# Access Compliance Report

## Public Rights-of-Way

| Intersection ID: 30452                  | Main Street: CRESCENT_EXECUTIVE_DR | Cross Street: GREEN_RIDGE_DR            | Location: S            |
| ADA ID: C910D7C7B79F                    | Ramp Type: Perp                    | Initial Pass/Fail: Fail                 | Overall Compliance: No |

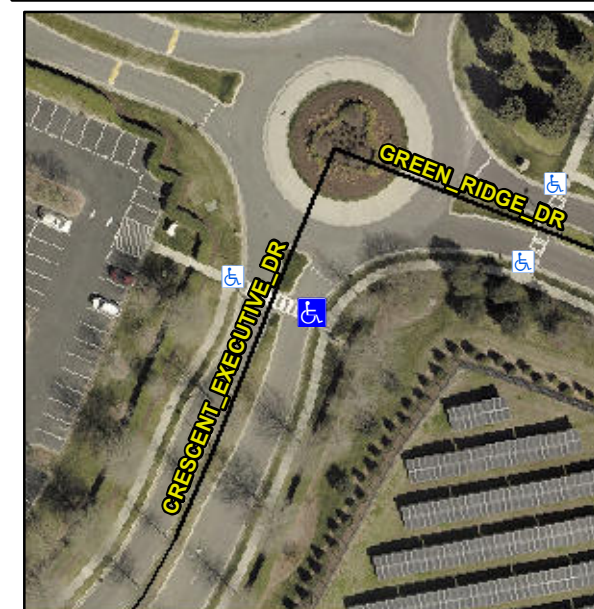
**Not Found, R304.2.2, R304.5.3**

| Compliance | Description           | Data  | Compliance | Description                 | Data |
|------------|-----------------------|-------|------------|-----------------------------|------|
| N/A        | Ramp Length (in)      | 48.0  | No         | Ramp Slope (%)              | 8.4  |
| Yes        | Ramp Width (in)       | 96.0  | No         | Ramp XSlope (%)             | 3.9  |

**Remove & Replace Entire Ramp.  
Restripe Crosswalk.**
